**Appendix Z. Draft Environmental Impact Statement/Resource Management Plan
Amendments Public Comments and Responses Part 6**

Project: DOI-BLM-NV-0000-2022-0004-EIS - Greenlink West Transmission Project

Brian Buttazoni, Planning & Environmental Specialist,
Bureau of Land Management
1340 Financial Boulevard,
Reno, NV 89502
Re: Comments on the DEIS for Greenlink West Transmission Project

Re: Comments on the Greenlink West Transmission Project Draft Environmental Impact Statement/Resource Management Plan Amendment - DOI-BLM-NV-0000-2022-0004-EIS

Map 1. GreenLink West intersection with the Bi-State Sage-grouse Mount Grant Population Management Unit (PMU).

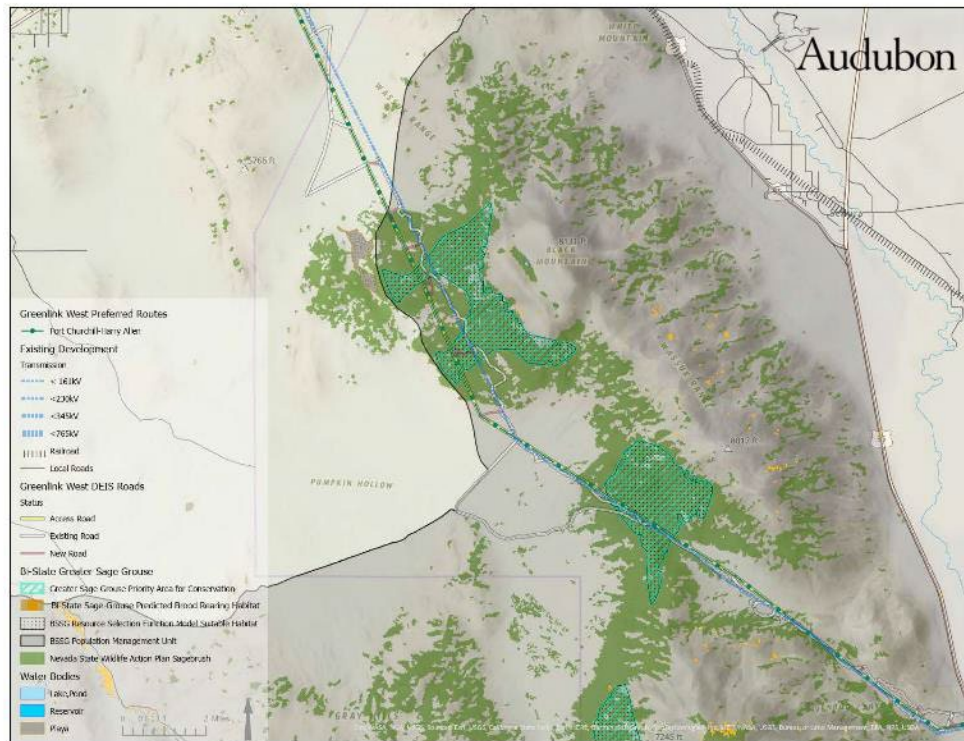
As proposed, there would be additional acres of ROW and road disturbance in the northern Mount Grant Priority Area for Conservation (PAC). The line must be collocated as shown in the lower PAC so as to add minimal new ROW and road disturbance for this route and to be in full compliance with the requirement in the BSSG LUPA.

Recommendation: change the alignment of the Fort Churchill-Harry Allen alternative and stay within the existing right-of-way where the line would pass through two Priority Areas for Conservation within the Mount Grant Population Management Unit; the deviation of the line from the existing ROW within the northern of these two PACs is inconsistent with the Bi-State Greater Sage-Grouse RMP

154.GG-3	<p>The proposed transmission line right-of-way (ROW) through the area referenced in the comment would be collocated with an existing H-frame transmission line and would be located within a West-wide Energy Corridor (WVEC). The BLM Preferred Alternative would conform with the management objectives for the area, because the 2016 LUPA allows for tall structures to be installed within four miles of an active or pending lek in existing corridors (such as the WVEC). Within the area of Bi-state habitat crossed by the existing line and the proposed Greenlink West Transmission Project (GLWP) ROW, the distance between the existing line and proposed ROW varies from approximately 1,500 feet to 1,900 feet. The Proponent has designed the proposed ROW in this area to follow the existing transmission line, to the extent feasible due to steep terrain, and stay within the WVEC corridor consistent with existing regulations and industry standards for collocation separation distances. The Proponent has also designed the proposed ROW to utilize as much of the existing access road as possible in order to minimize additional fragmentation of sagebrush vegetation resulting from new access road segments. This comment has not resulted in a change to the document.</p>

Map 2. GreenLink West intersection with the Bi-State Sage-grouse Pine Nut Mountains Population Management Unit (PMU).

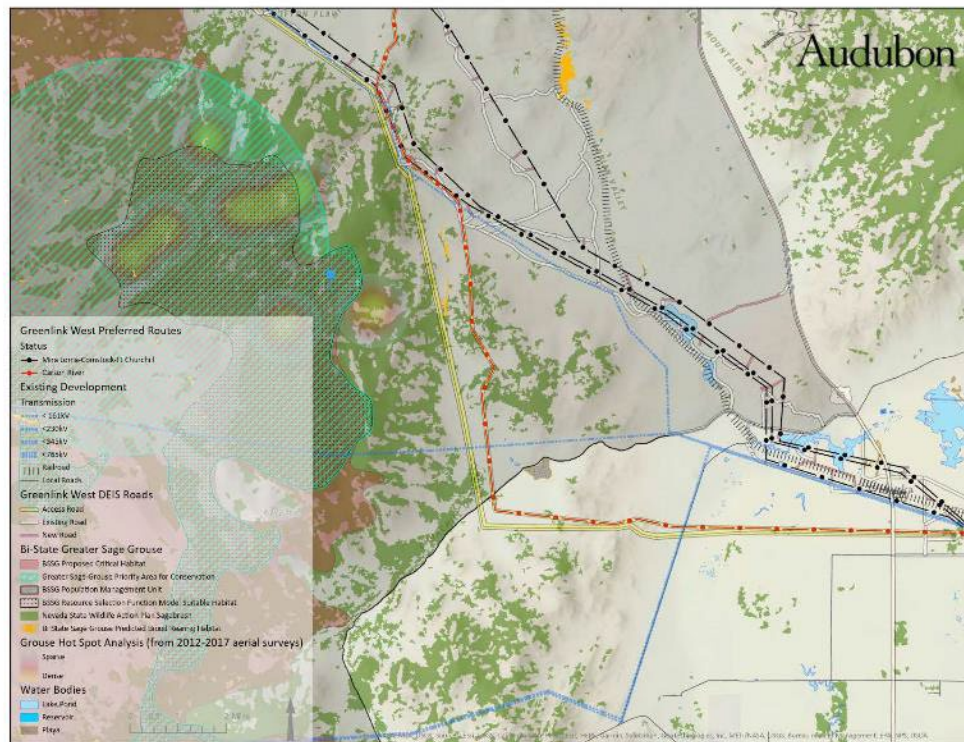
A second area of potentially greater concern is the preferred Carson River Alternative C (See Appendix for Map 2), which is not within a WWEC or collocated with existing transmission lines and would carve a swathe of new disturbance close to recent sage-grouse activity within the Pine Nut Mountains PMU. This is purportedly to avoid rare plant impacts and impacts to roads used for military training. The logic of this tradeoff is inscrutable considering the conservation status of the Bi State Sage-grouse and the particular situation in this PMU.

This proposed route would add over 1500 acres of temporary and 500 acres of permanent disturbance within the PMU,⁹ which already has a plethora of “high” risk factors – including but not limited to infrastructure, wind development, human disturbance, and invasive species (cheatgrass). Only 1.5% total disturbance is allowed in the Pine Nut Mountains PMU per the BSSG LUPA.¹⁰ The contribution of the proposed disturbance to the existing disturbance already present, and whether this would be in compliance with BLM’s management objectives, was not addressed in the DEIS. Regardless, the proposed additional disturbance is clearly unnecessary and must be avoided.

154.GG-4	<p>Approximately 14,000 acres of the Pine Nut PMU was burned by the Adrian Fire in 2007, affecting the suitability as Bi-state sage-grouse habitat. Portions of the Carson River Transmission Alternative C would cross through this burned area. Additionally, no recent lek activity has been observed within this area according to data received from the Nevada Department of Wildlife. This information has been added to the Final EIS/Proposed RMPA in Section 3.1.4.2.</p> <p>PMU designations are for planning purposes, do not reflect suitable habitat boundaries for the species, and do not provide regulatory protection for the species. The proposed transmission right-of-way under the Carson River Transmission Alternative C would not be located in mapped Bi-state sage-grouse habitat and is not located within the Greater Sage-Grouse Bi-State Distinct Population Segment Land Use Plan Amendment and Record of Decision Management Area. Refer to Draft EIS/RMPA Section 3.1.3.1 for information on suitable habitat and see response to Comment 154.GG-2.</p>

Figure 10. Photo of White-margin beardtongue habitat in Amargosa Valley (Center for Biological Diversity).

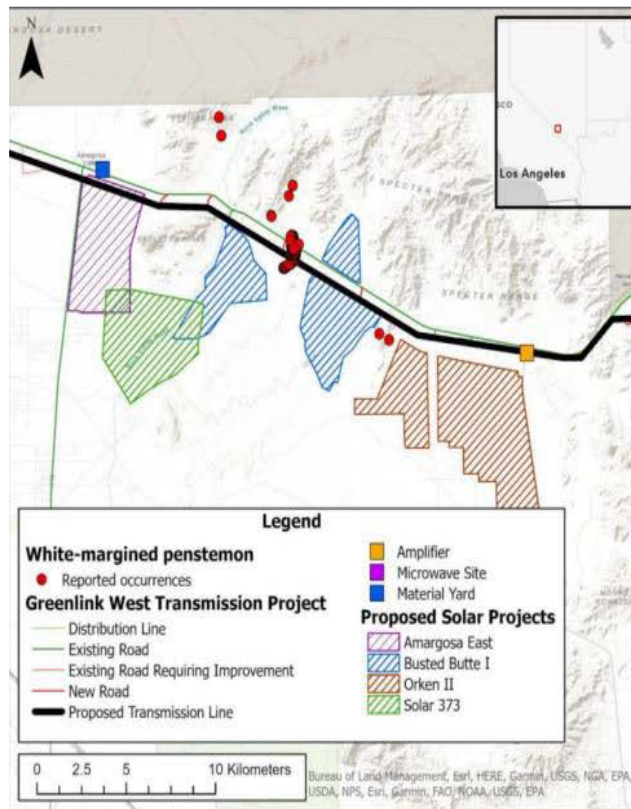
Greenlink West will cause habitat loss, alter drainage channels and cause erosion, bring in invasive weeds like Sahara mustard.

In spite of the species having the best bloom in years, BLM and NV Energy missed the window in April to survey for the species. Surveys still did not take place by August. The entire habitat experienced an intense heatwave during July, 2023. Missing the survey window will now result in surveyors finding traces of dried out plants. We have to wonder if the neglect was intentional because we requested BLM do this 3 times.

Figure 12. Map showing Priority One (purple) and Two (orange) Connectivity Habitat in Amargosa Valley

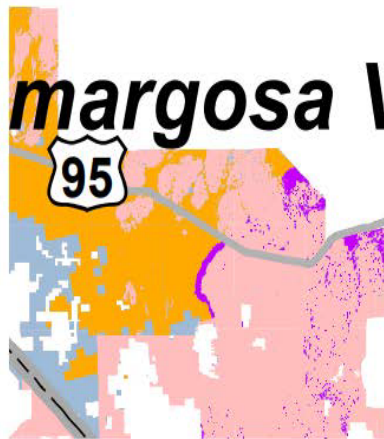
Greenlink will also create a spread of invasive weeds which are not nutritious for desert tortoises and perches for subsidized predators such as ravens. Is NV Energy planning to fence off Hwy 95 as mitigation?

Figure 13. Map of free-for-all solar land rush applications in Amargosa Valley, Nevada

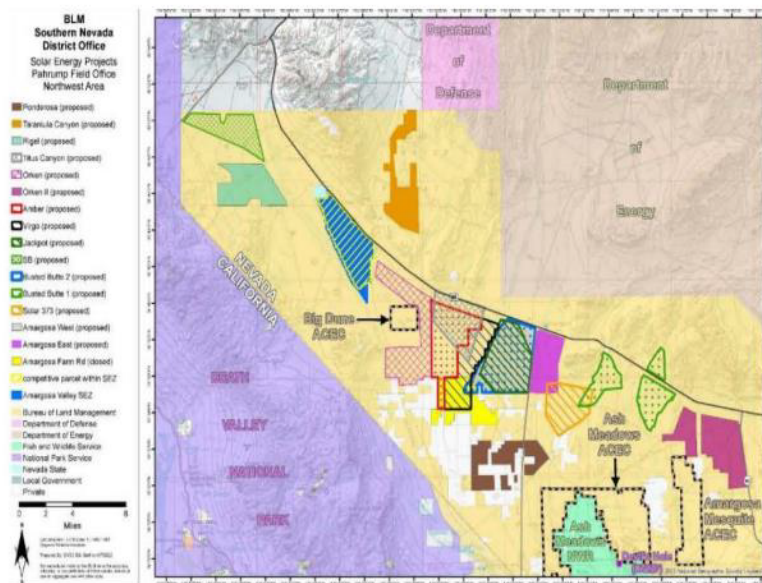
Connected actions are those proposed Federal actions that are "closely related" and "should be discussed" in the same NEPA document (40 CFR 1508.25 (a)(1)). Proposed actions are connected if they automatically trigger other actions that may require an environmental impact statement; cannot or will not proceed unless other actions are taken previously or simultaneously; or if the actions are interdependent parts of a larger action and depend upon the larger action for their justification (40 CFR 1508.25 (a)(1)). Connected actions are limited to Federal actions that are currently proposed (ripe for decision). Actions that are not yet proposed are not connected actions but may need to be analyzed in the cumulative effects analysis if they are reasonably foreseeable.¹⁸

Figure 14. 2012 map of tortoise sign located

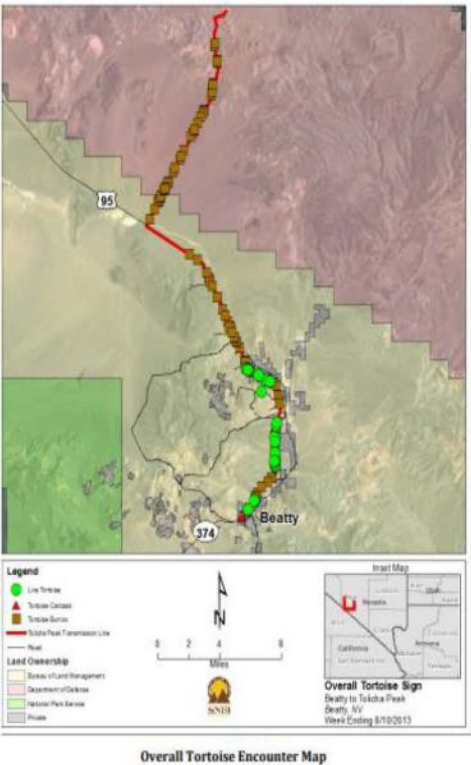
In 2012, BLM approved the Tolicha Peak Transmission line north and west of Beatty. During desert tortoise surveys, far more were found than expected including along the path of Greenlink West.
